CORNFIELD ARROYO SECO SPECIFIC PLAN

**CORNFIELD ARROYO SECO SPECIFIC PLAN
FINAL ENVIRONMENTAL IMPACT REPORT**

RESPONSE TO COMMENTS

Figure 4-7
Bicycle Network
Cumulative (2035) Plus
Proposed Alternative Conditions
 Cornfield Arroyo Seco Specific Plan
 Final EIR

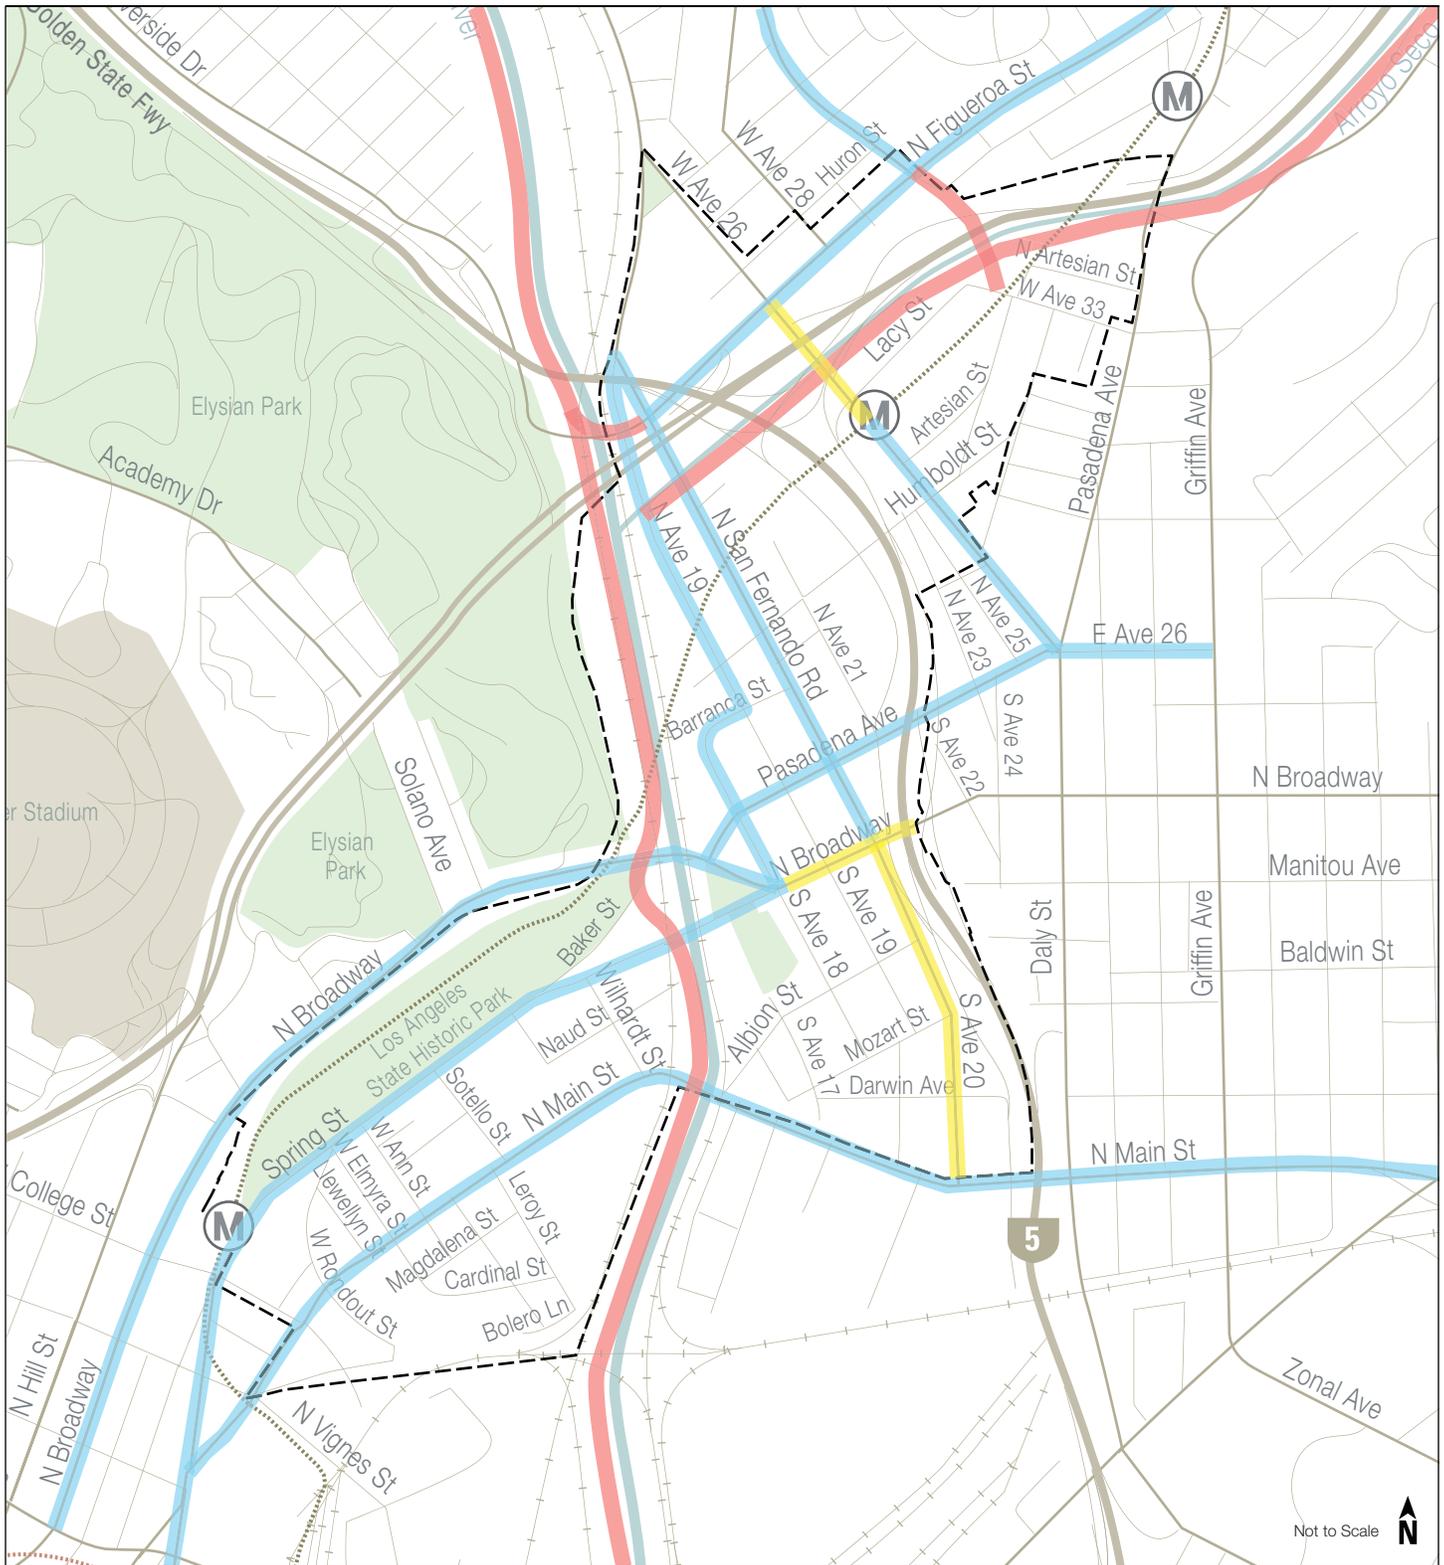
The Original DEIR illustrates the bicycle network for the Proposed Alternative (DEIR Figure 4-7, p. 4-30). Continuity is provided between the Class II bike lanes proposed for West Broadway and San Fernando Road via Class II bike lanes proposed for Avenue 18 and Pasadena Avenue, enabling a cyclist to travel from North Broadway to North San Fernando Road on a continuous Class II bike lane; therefore, there is no safety hazard to address.

Page 4-29, section 4.3.1.7, Figure 4-7, The section of Avenue 26 between Figueroa Street and Lacy Street is shaded yellow to indicate a bicycle route. The section of Avenue 20 between Broadway and Main Street is shaded yellow to indicate a bicycle route. The section of N. Broadway between S. Avenue 18 and I-5 is shaded yellow to indicate a bicycle route including signage and roadway markings as permitted for a Major Class Roadway with peak hour lanes until which time a Bicycle Lane can be accommodated in this section of roadway as envisioned by the 2010 Bicycle Plan.

Page 4-29, Figure 4-7 is revised to include the additional bicycle routes on Avenue 26, Avenue 20, and Broadway. See Figure 4-7 in the figures section at the rear of this chapter.

Figure 5-17
Shadow Analysis
Typical Hours of Shade December 21
 Cornfield Arroyo Seco Specific Plan Final EIR

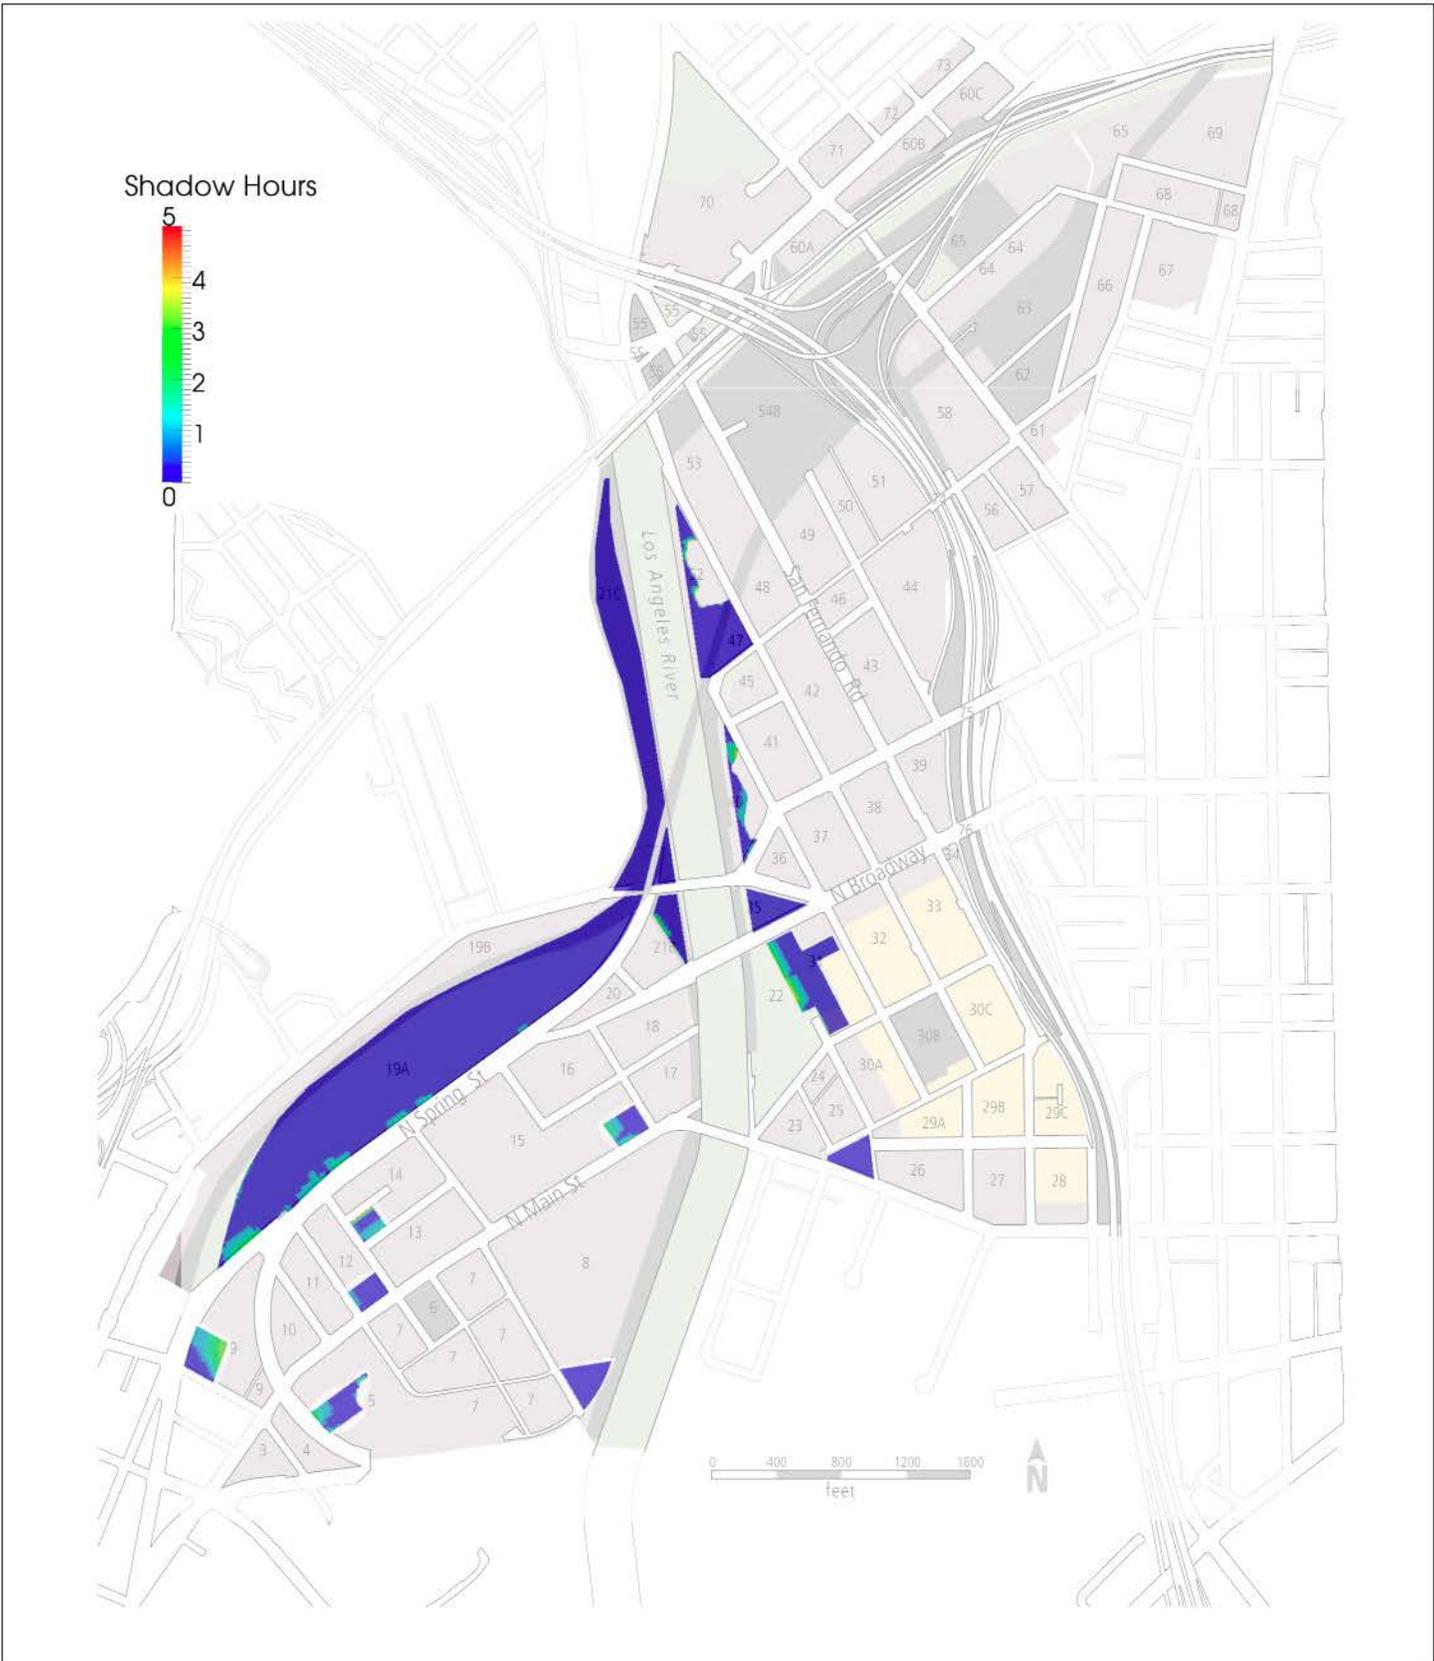
27-109 The comment expresses concern about viewshed and shadow impacts from any new construction along Broadway, north of the State Park, to the Solano Canyon area. Figure 5-17 in Section 4 Corrections and Additions illustrates proposed shadow conditions generated by the proposed alternative.

Potential impacts from shadows generated by new building are addressed in the Original DEIR on page 9-22. Buildings are to be designed so that no more than three hours of shadow will be generated on parks, open space or abutting rooftop areas between 10 a.m. and 2 p.m. on December 21. Figure 5-17 in Section 4 Corrections and Additions shows projected modeled hours of shade for December 21.

Figure 7-7
Groundwater Basin Boundaries in
the Vicinity of the Plan Area

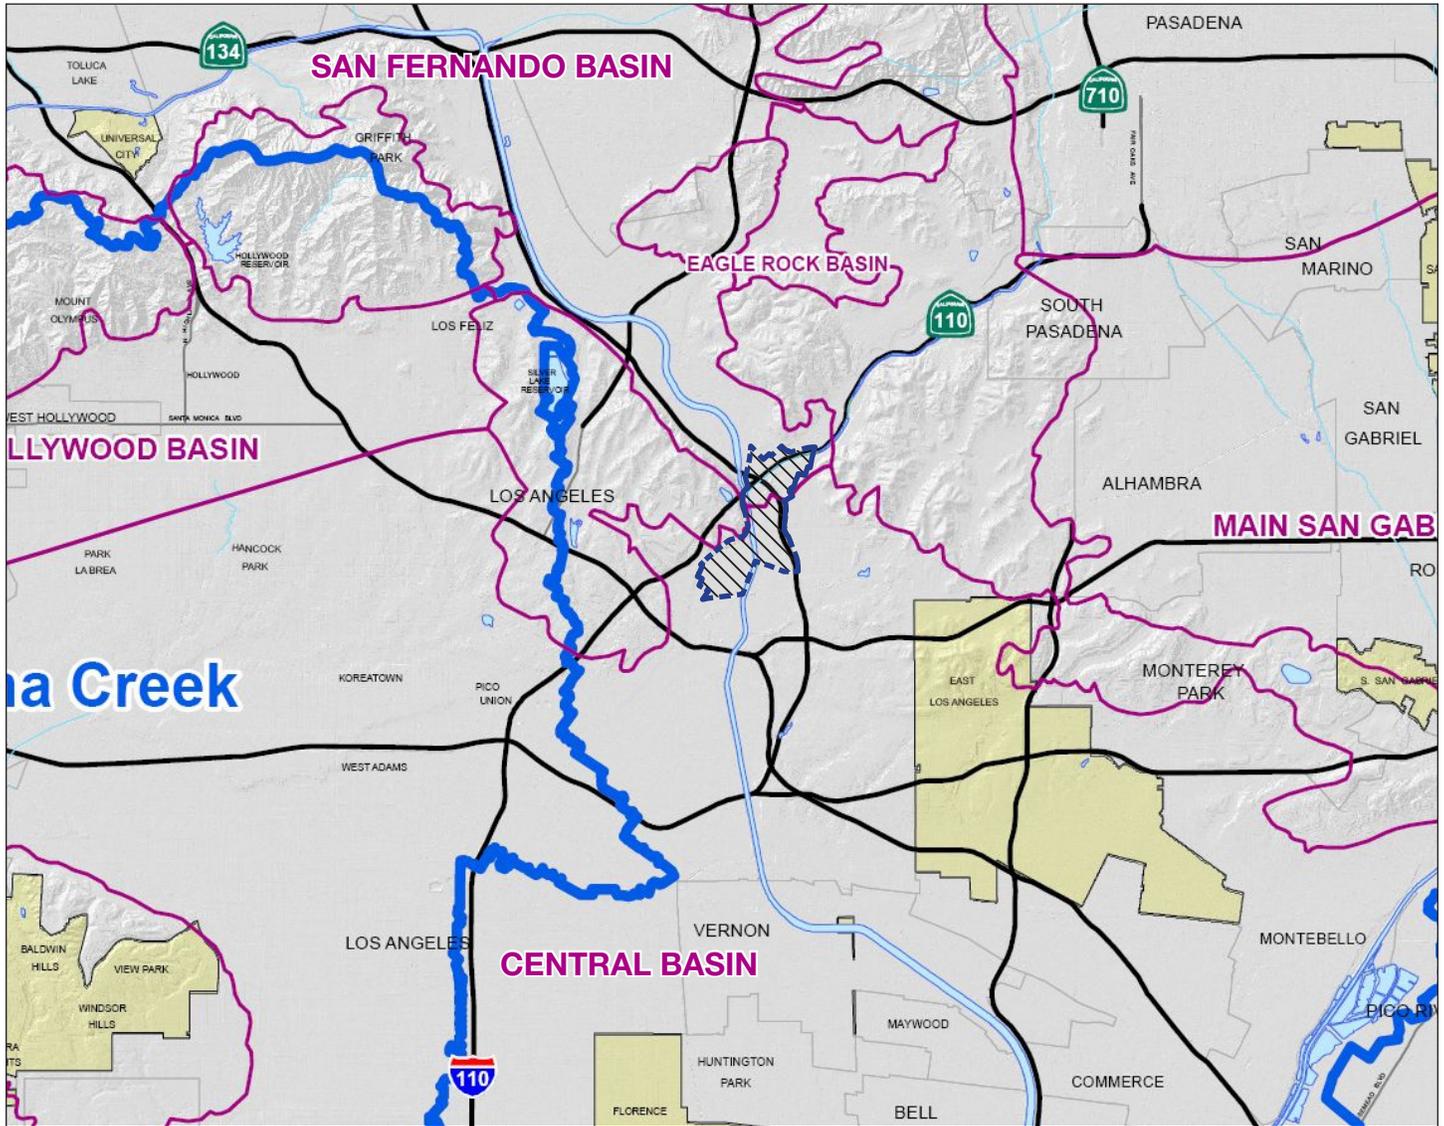
40-152 The comment indicates that Figure 7-7 does not name the Central or San Fernando Basins. The comment also appears to present facts as to the groundwater flow and mentions that groundwater level is 200 feet below the ground surface in the Project Area and lies in the Puente Formation. However, the comment presents no information as to any deficiencies with the analysis. Groundwater is discussed on pages 7-13 to 7-16 of the Original DEIR.

The comment is noted and Figure 7-7 has been revised. Please see Corrections and Additions. The information provided in Figure 7-8 is intended to compliment the more detailed information in the text of Section 7.1.6 which describes in narrative the groundwater levels and flows of the Original DEIR. A comprehensive map of groundwater contours of the Central Groundwater Basin and San Fernando Groundwater Basin is beyond the scope of the analysis.

Page 7-14, Figure 7-7 is revised to include references to the San Fernando and Central Basins. See Figure 7-7 in the figures section at the rear of this chapter.

**Figure 10-1
CERCLA Sites**

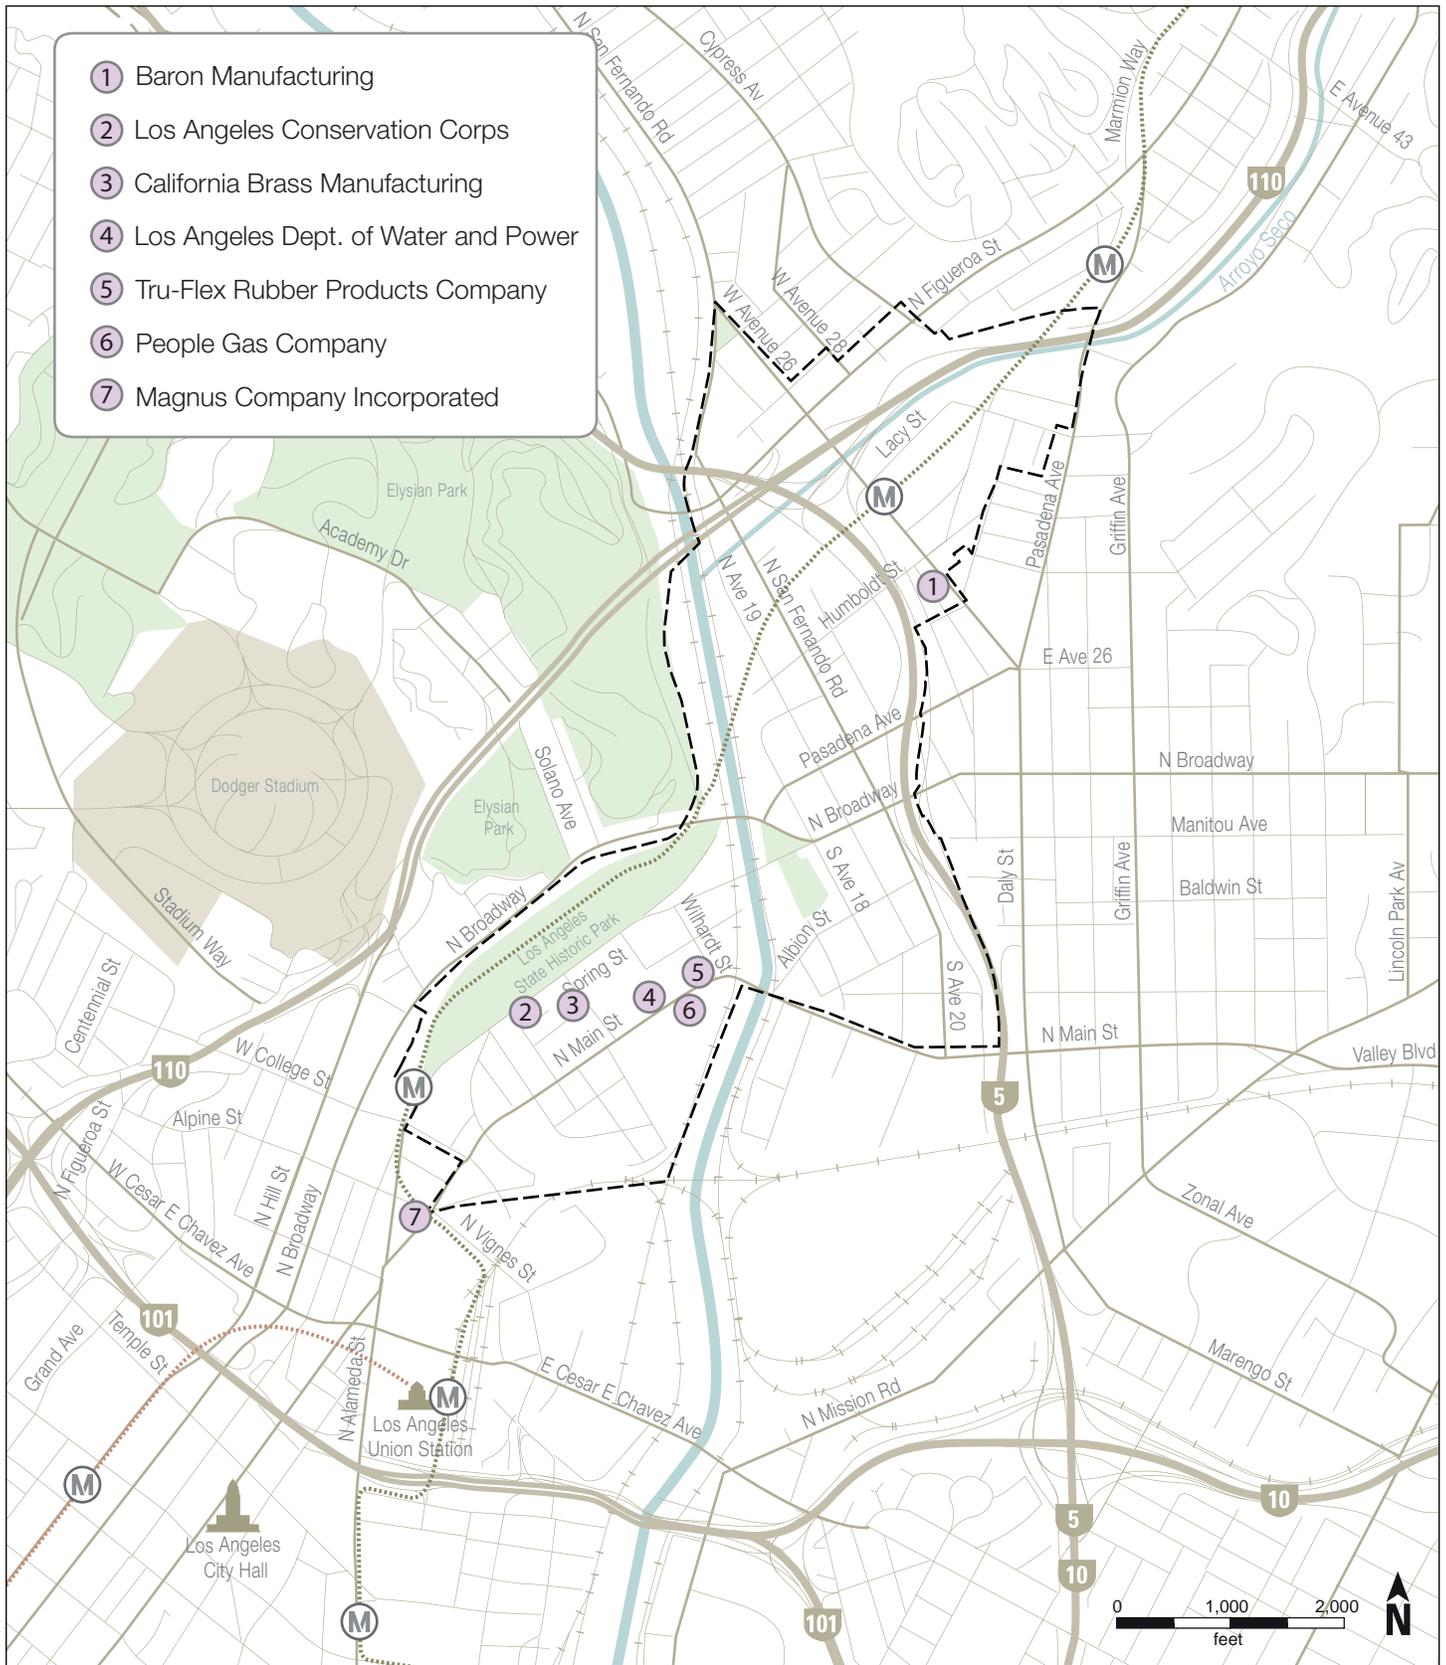
- 27-100 The comment states that the Original DEIR did not provide graphics showing the location of the 3 additional EPA Superfund, 2 additional Cortese list, 18 additional sites with histories of contamination, corrective action, or other hazardous waste issues, 49 registered oil and gas wells and three dozen underground or above ground storage tanks within the Project Area. Figure 10-1 has been added and replaces 10-1 in the Original DEIR (which is now Figure 10-2, Pollock Well Field, see Response to Comment 27-99)

The database identifies seven additional CERCLA or potential Superfund sites where no further assessment has been completed and no further steps will be taken to list them on the NPL. While these locations are not judged to be potential NPL sites, it does not mean there is no potential hazard associated with the sites. The sites are listed as follows (see Figure 10-1):
